Mandatory Referral Review

TPE MD PR270 LLC Allentown Road Solar

- **PRINCE GEORGE'S COUNTY PLANNING BOARD**

- **May 19, 2022**

SITE PLAN

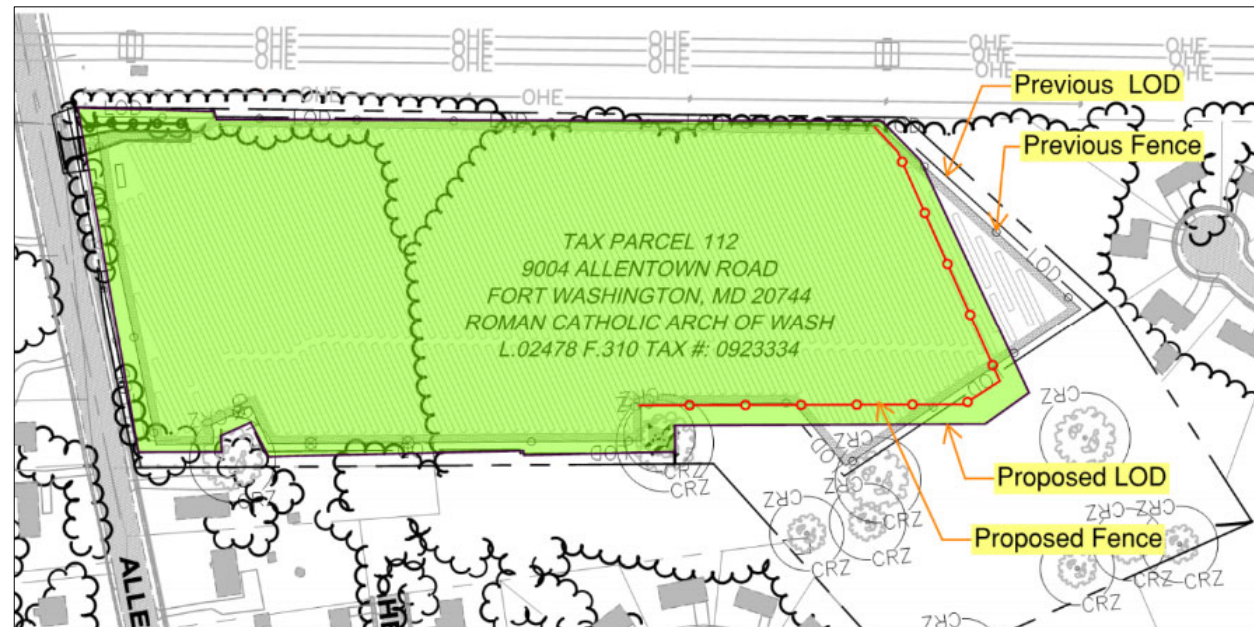
Revised from previous site plan to reduce the off-site woodland conservation mitigation from 1.67 acres to 0.98 acres.
